Addendum No. 3

Project: 2018 Physical Education Facilities
North Harrison Middle School
Ramsey, Indiana

Proj. No: 1518.03

Date: December 12, 2017

Revisions	1	2	3	4	5	6
Drawn	HK					
Checked By	HK					
Project No.	1581.03					
Date	12/12/2017					
Certified By

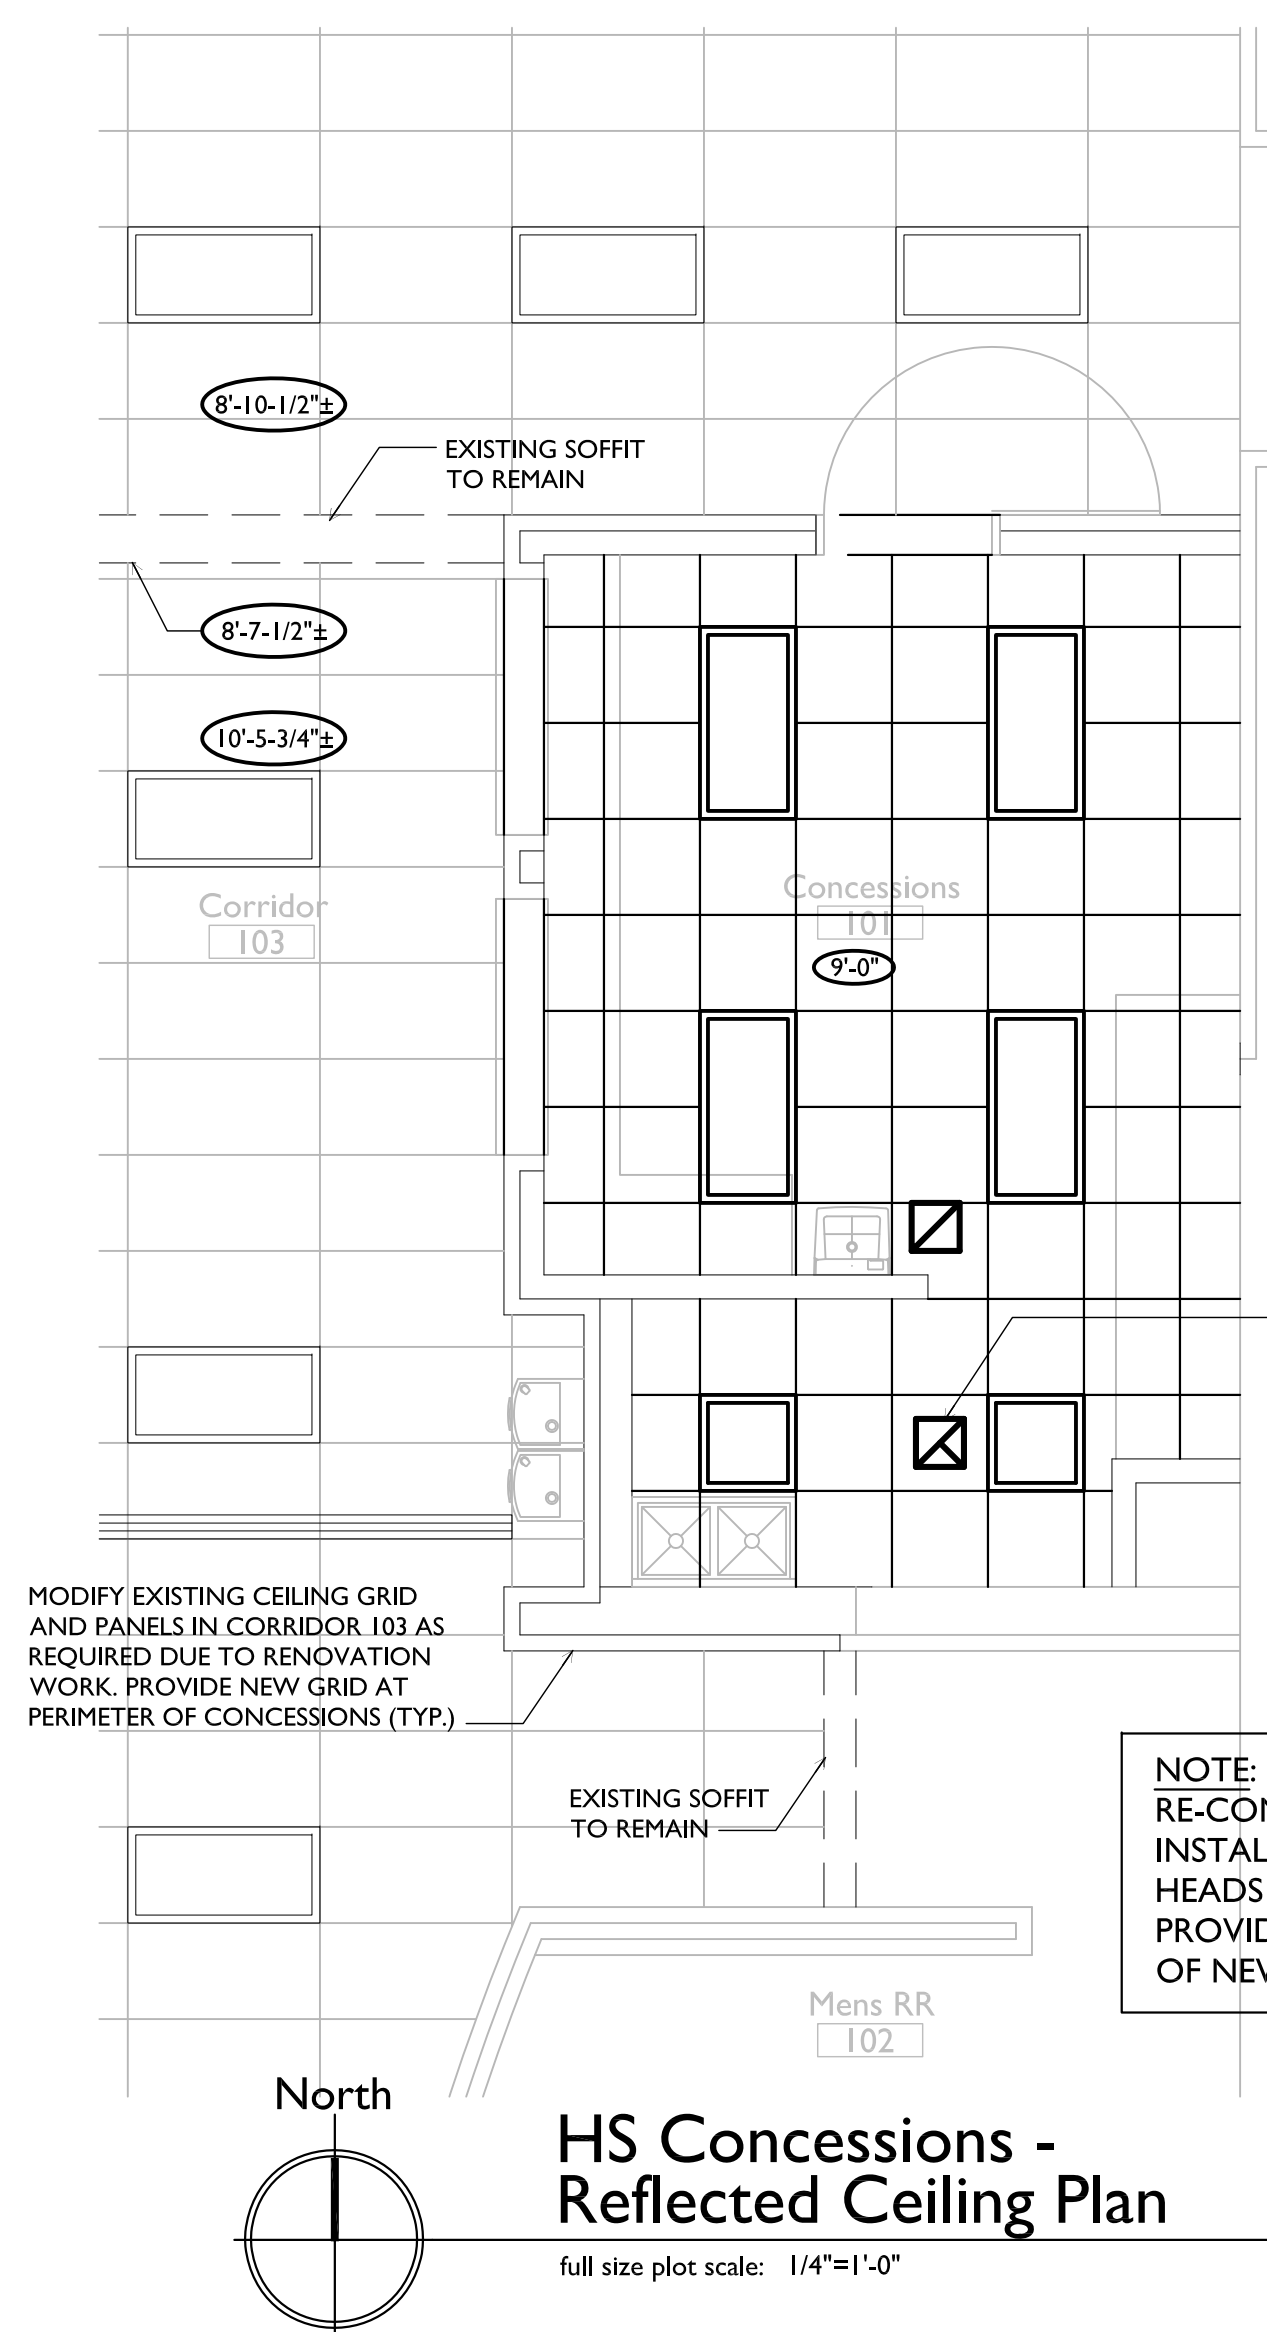
The Code Summary Table floor areas of the Middle School & High School were combined. A revised table is included with this addendum in drawing AD3-1.

AREAS FOR MIDDLE SCHOOL AND HIGH SCHOOL WERE COMBINED
IN THE CODE SUMMARY TABLE ON SHEET G-101. ABOVE ARE THE
CORRECTED AREAS PER BUILDING.
